High Road West

Whitehall Mews (Plot A)

Comparison between Planning Submission (October 2021) and Current Proposal
July 2022

Revisions	
Rev	C
Date	2022-10-03
Notes	Non Material Amendment Final Submission

North elevation

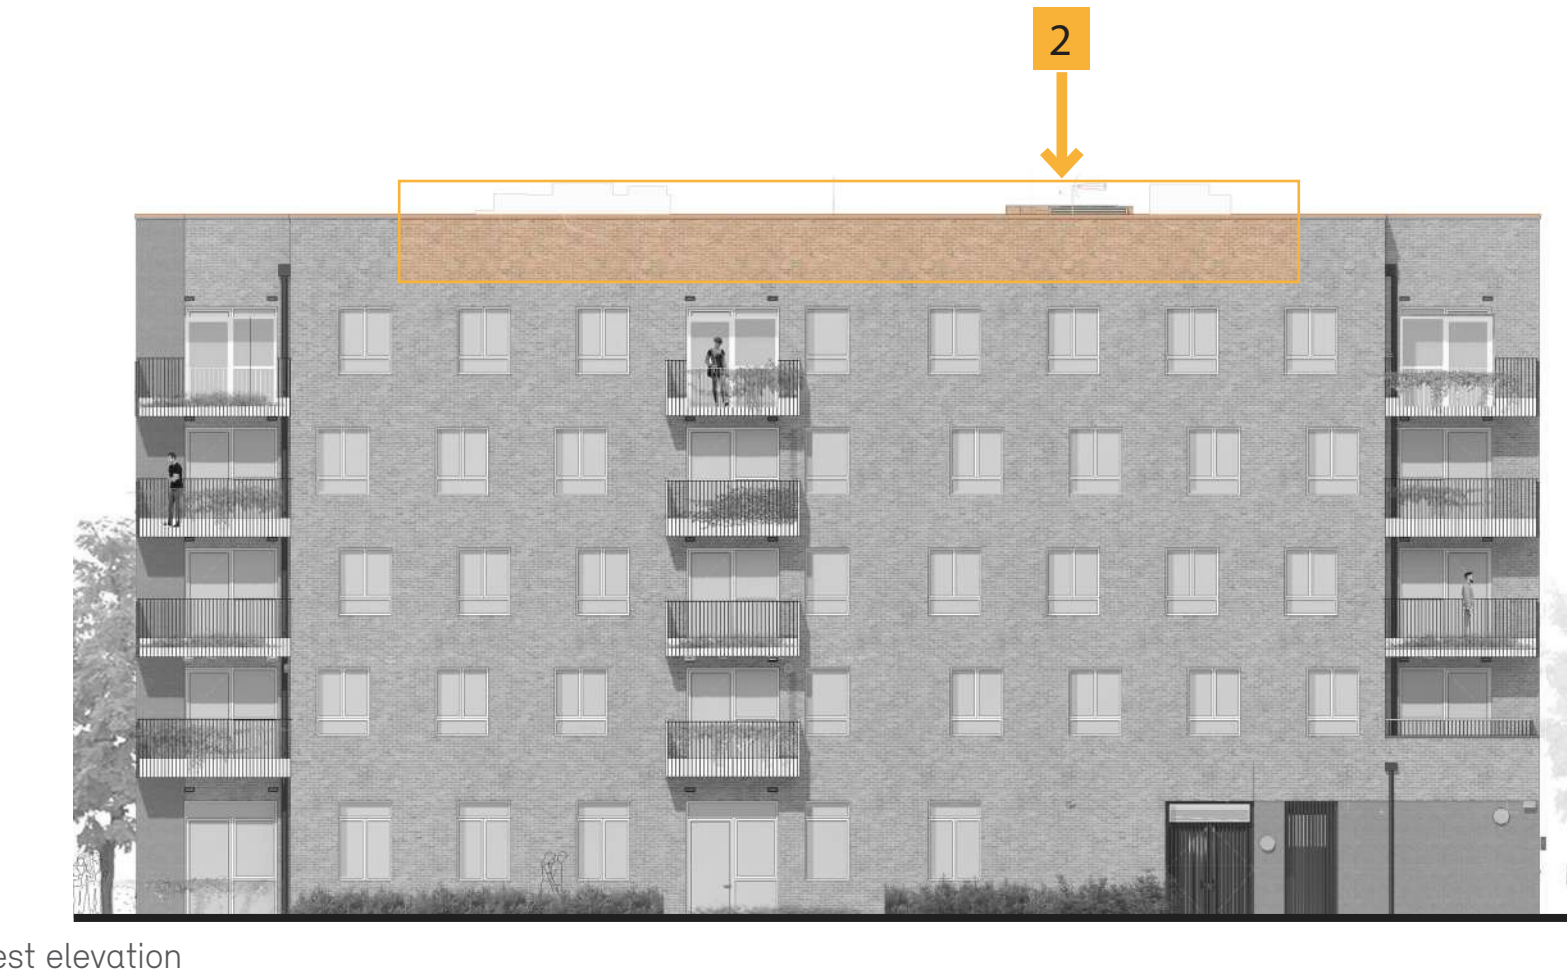
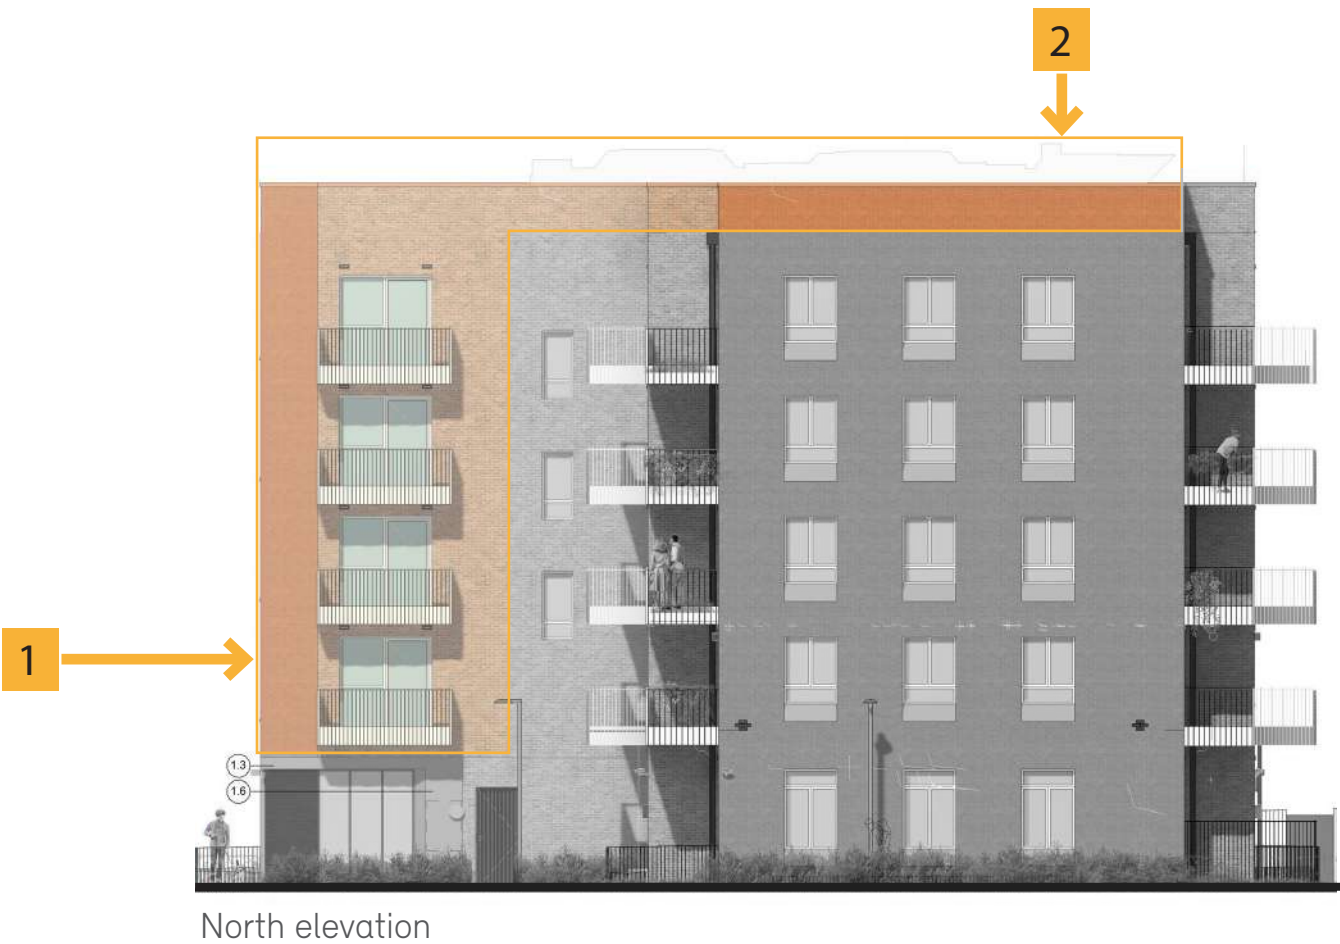
1. Due to the internal layout changes, there are additional balconies to the 1B2P apartment, facing onto Whitehall Mews.

2. Plant on roof.

This elevation now has 4 additional projecting balconies due to the changes to the internal layouts. 4no. 1B2Ps are stacked above the main entrance to Building A1. The balconies have been located so that they are overlooking the Whitehall Mews garden.

4.1 Duplex changes

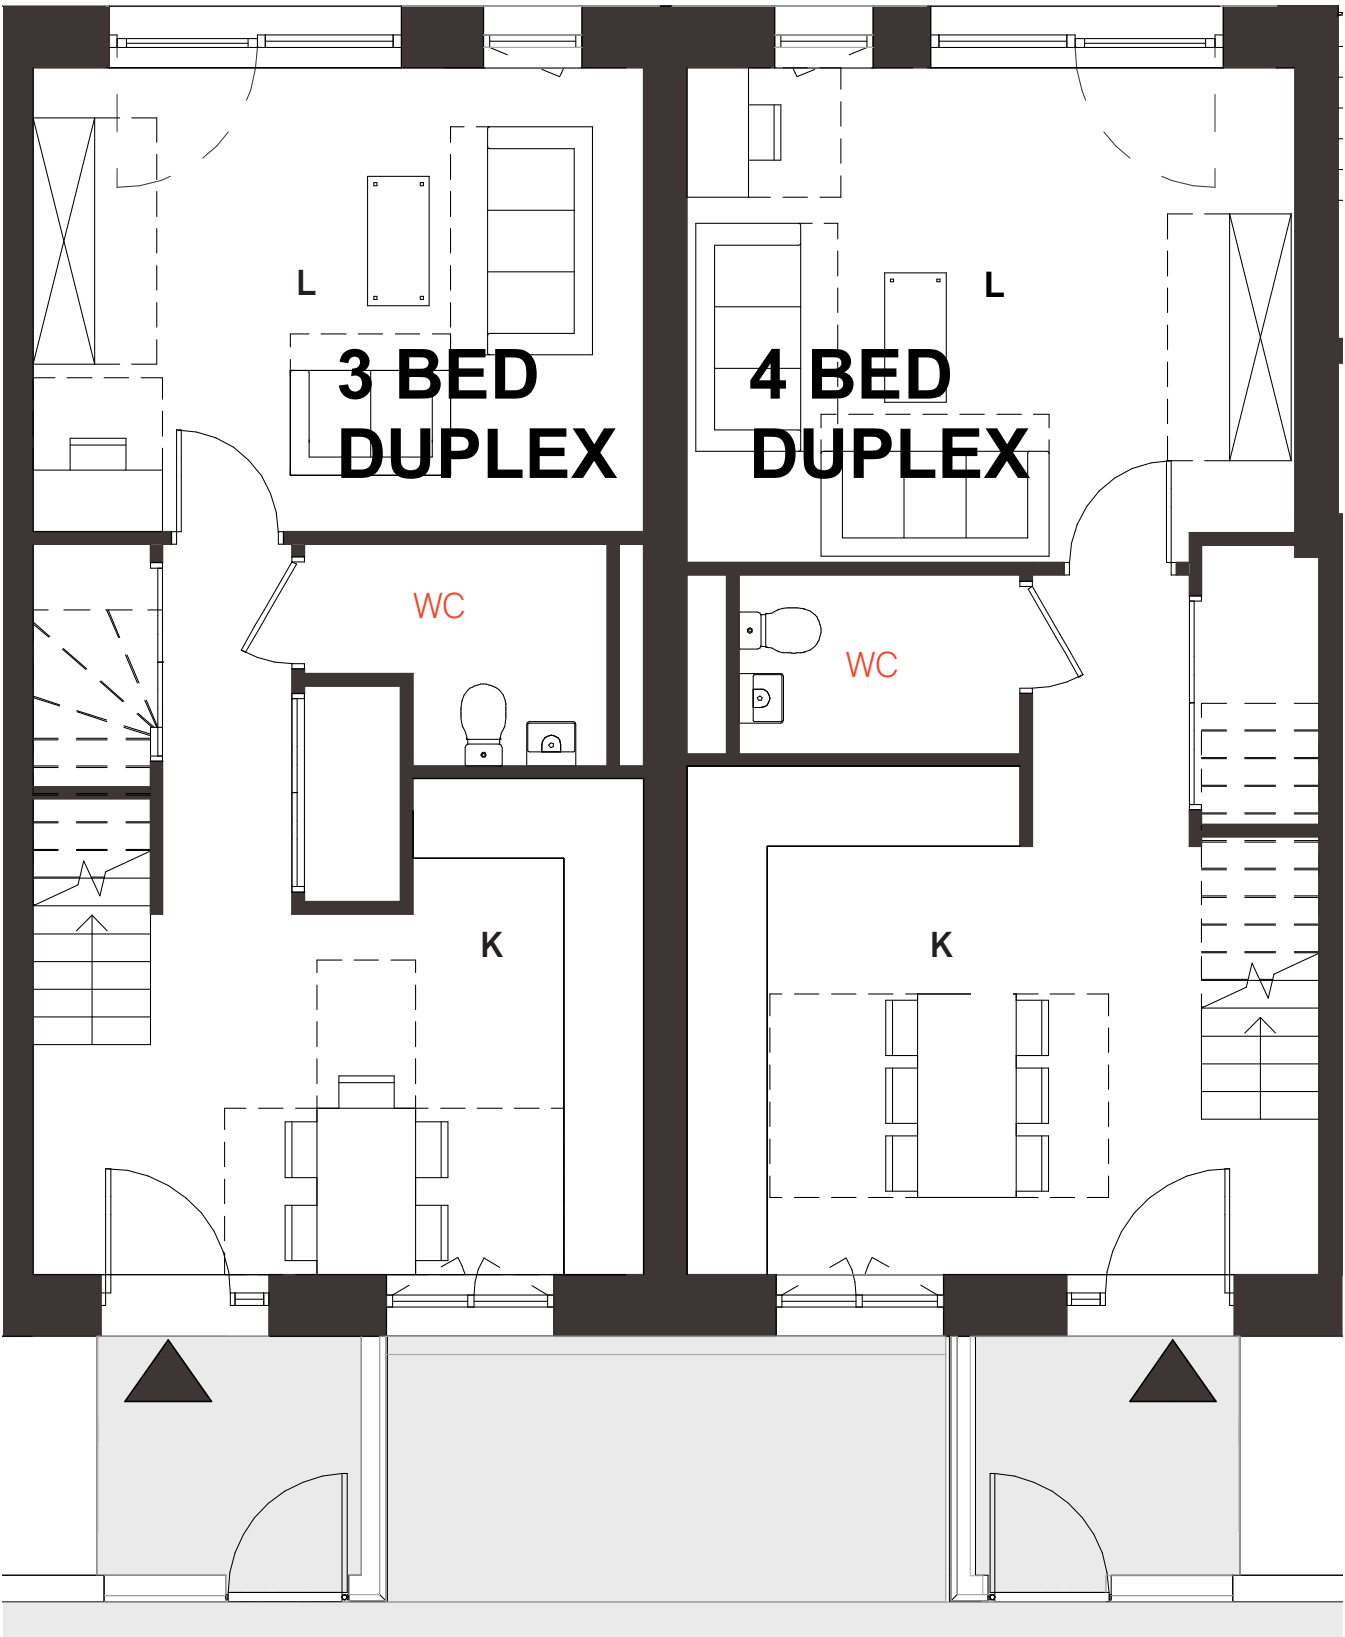
- Minor alterations to layout of ground floor duplexes
- Ground floor windows to Building A2-A3 have raised sill (1100mm).

Layout amendments to the ground floor of the duplexes have been carried out following discussions with LBH’s Regeneration and Housing Teams, which have included increasing the 4B6P Duplex’s downstairs WC to a shower room, and re-orientating the kitchens so that they sit underneath the windows. This change has raised the window sill to the ground floor kitchen to 1100mm (previously 675mm), and has created more flexibility and storage space within the kitchen. Consil (Daylight Consultant) has tested the change in sill height, which would cause relatively small reductions in daylight amenity within the kitchen/dining room (around 0.2% ADF).

4.1 Duplex changes

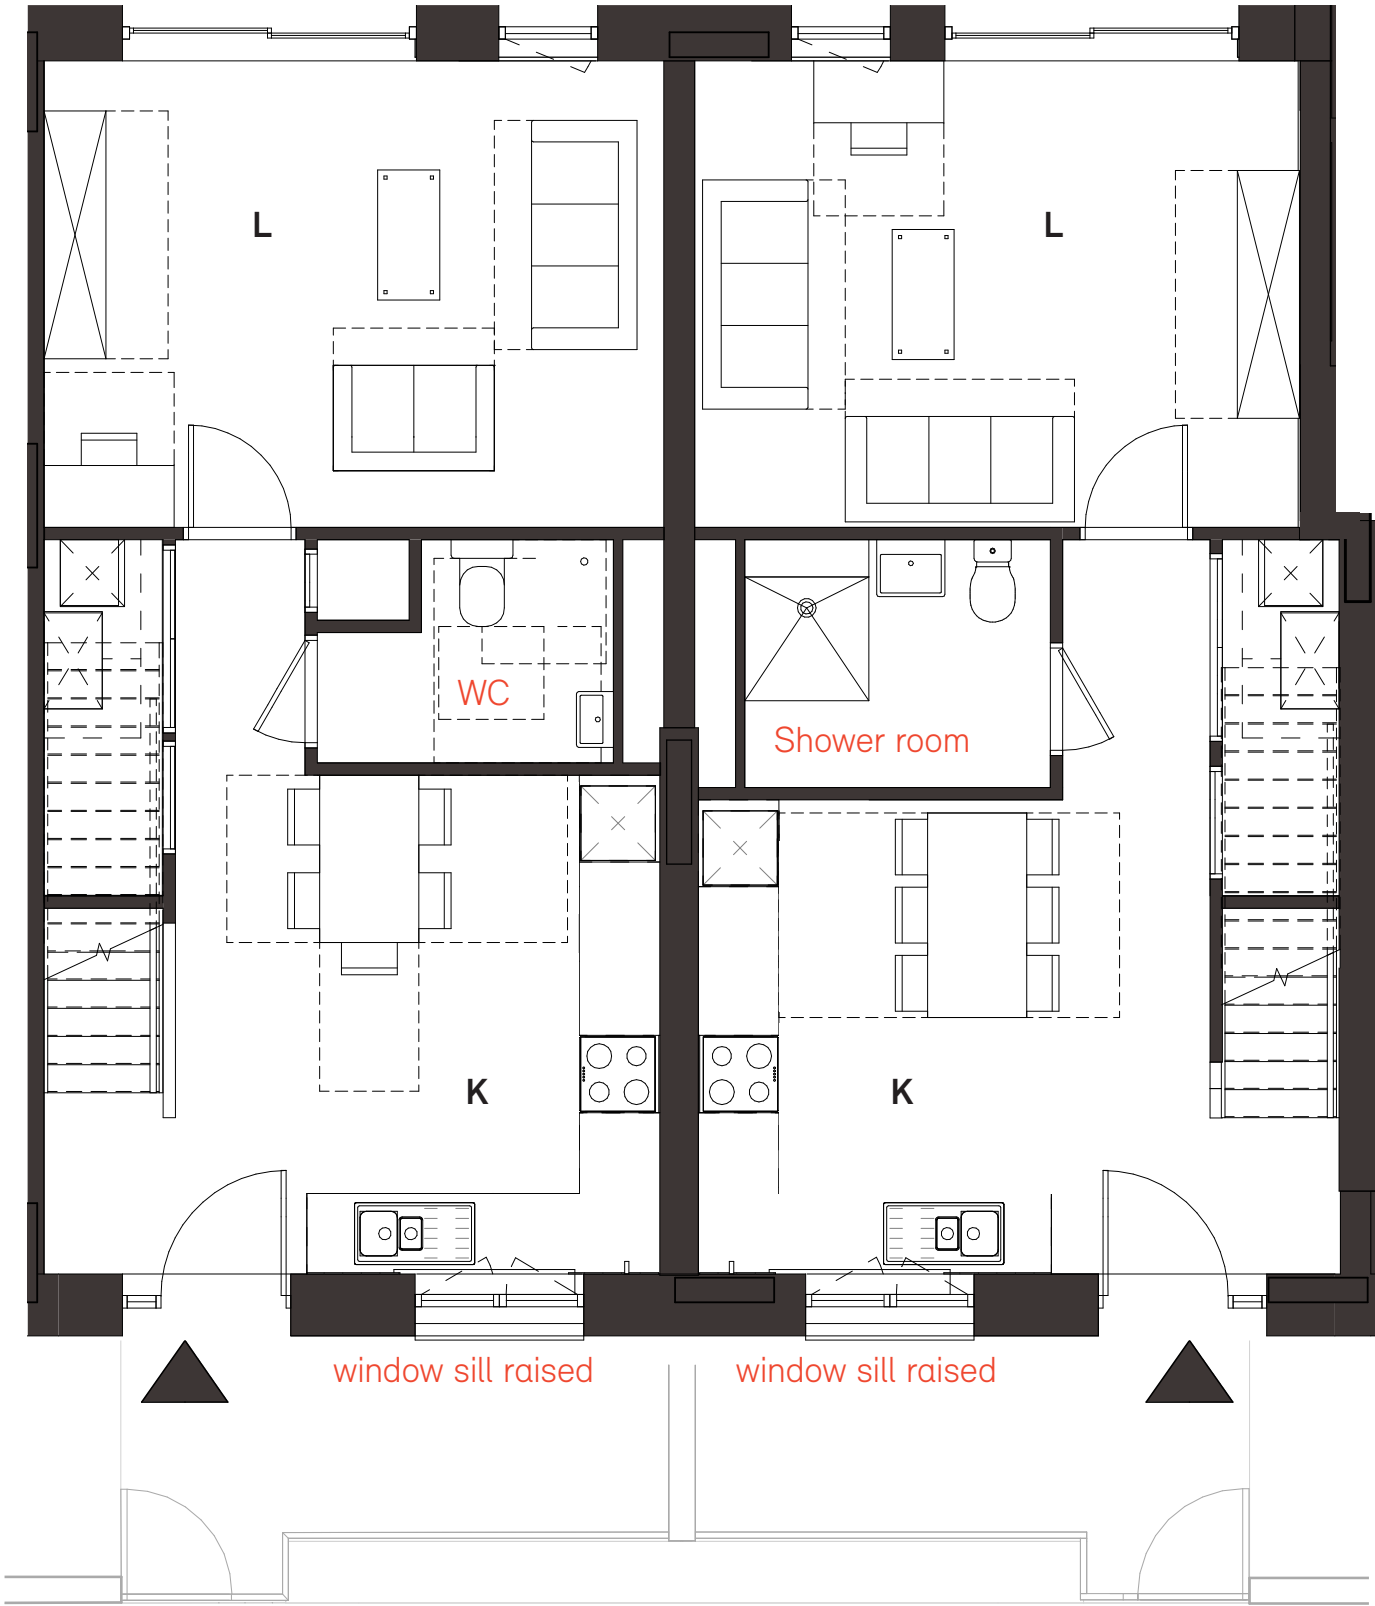
- 1. Minor alterations to South and West elevations.
- 2. No changes to East and North elevations.

Duplex ground floor window with 675mm cill

Duplex ground floor window with 1100mm cill

6.0 Landscape changes - A2-A3

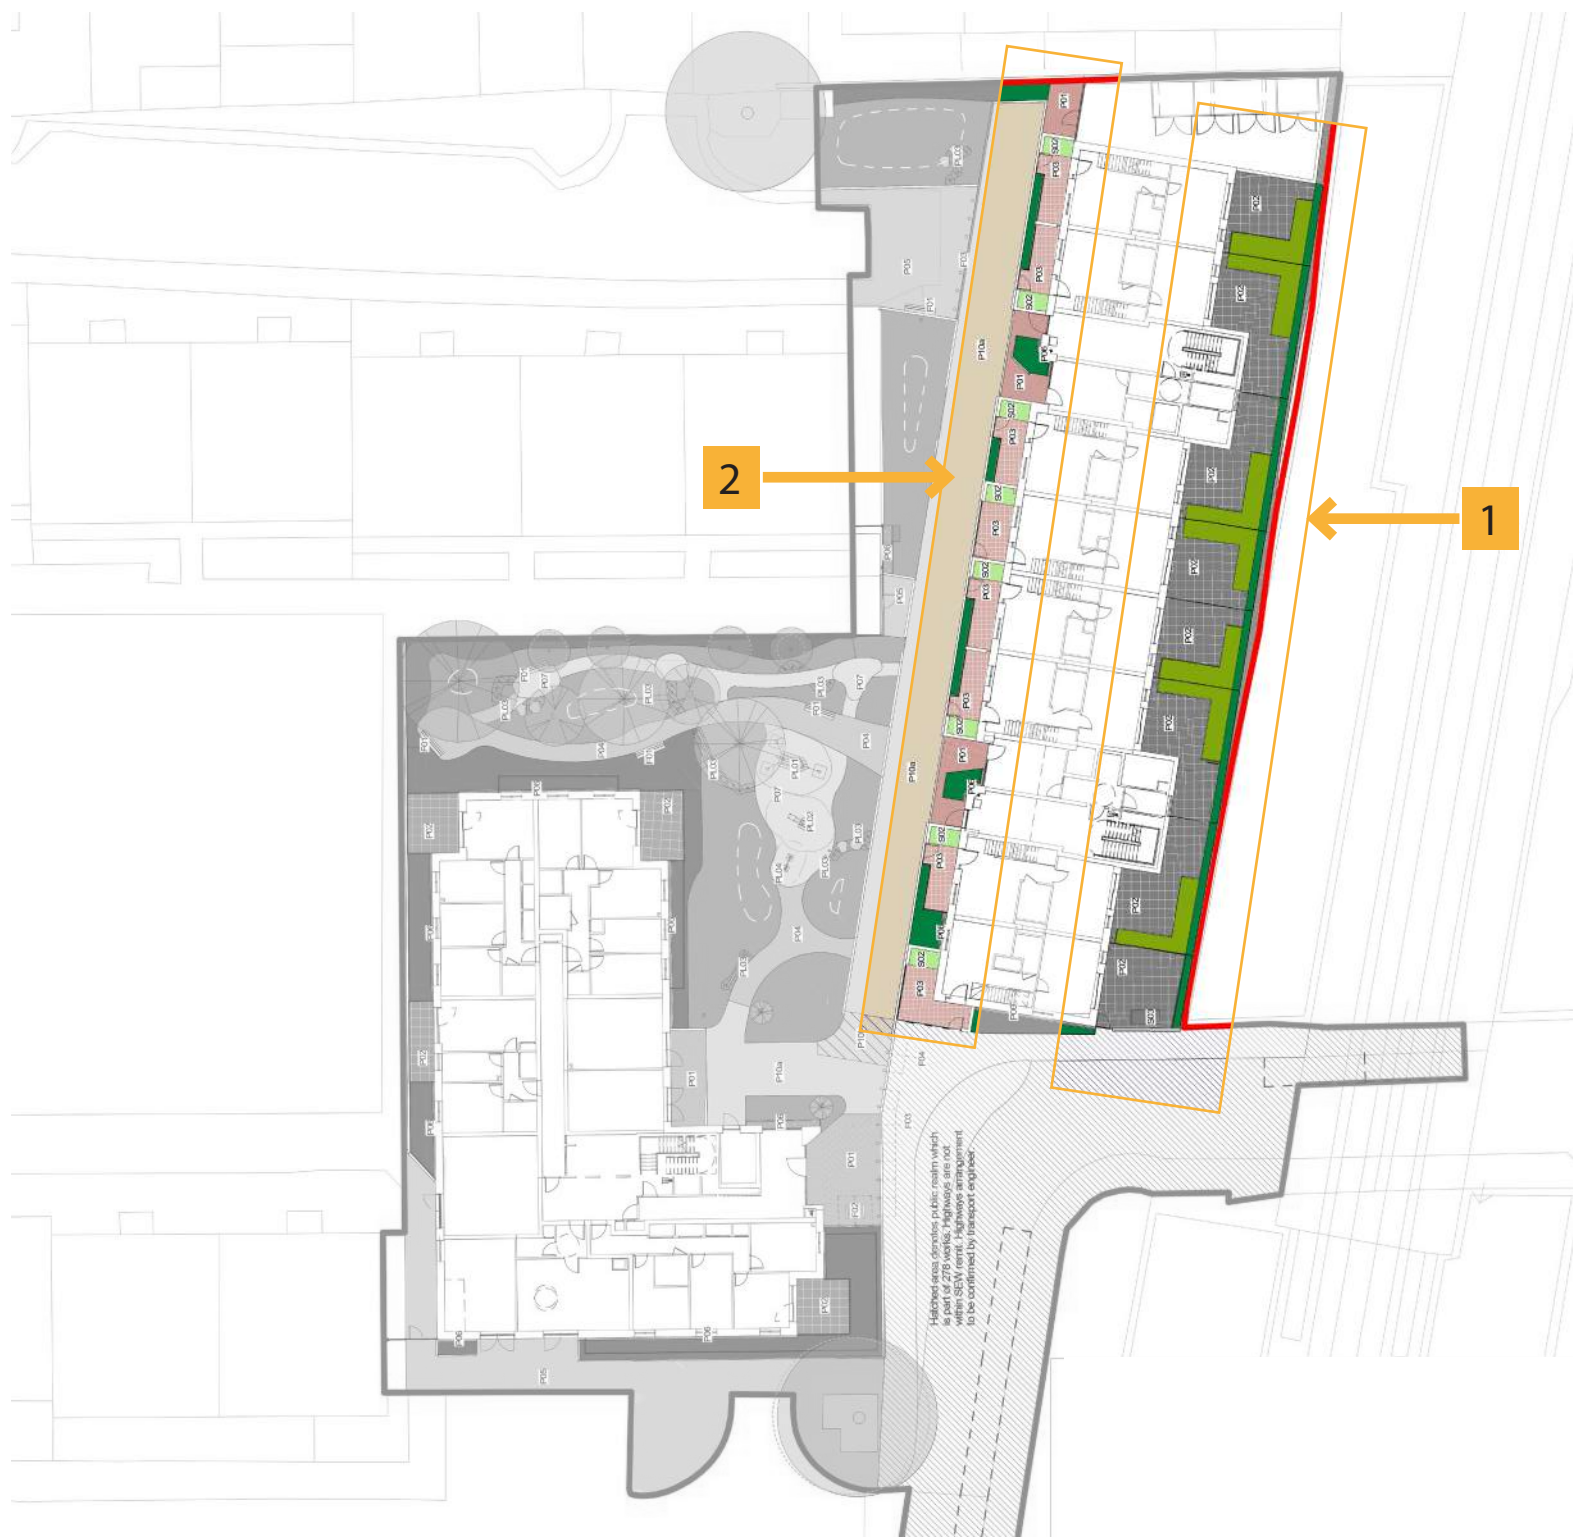
Changes to landscape following LBH Housing comments:

- 1. Change to rear duplex gardens arrangement. There were concerns from LBH around the size of lawns being too small to justify the required maintenance and storage space for a mower in each garden. Gardens have been altered to provide more hardstanding for flexible use throughout the year. Planting and hedging to the rear of the gardens was found to be more appropriate to the scale of the garden space, providing amenity value to residents whilst also uplifting biodiversity value from the previous design.

- 2. Change to duplex front entrances. There were concerns from LBH that the front garden entrances were too small and whether options could be explored to move the bike stores to the front. It was advised by Secure by Design to include knee-rails to all defensible planting to deter access to windows. The front gardens have been altered to provide more hardstanding for residents to personalise and take ownership of their space, with hedging and railings to delineate defensible space.
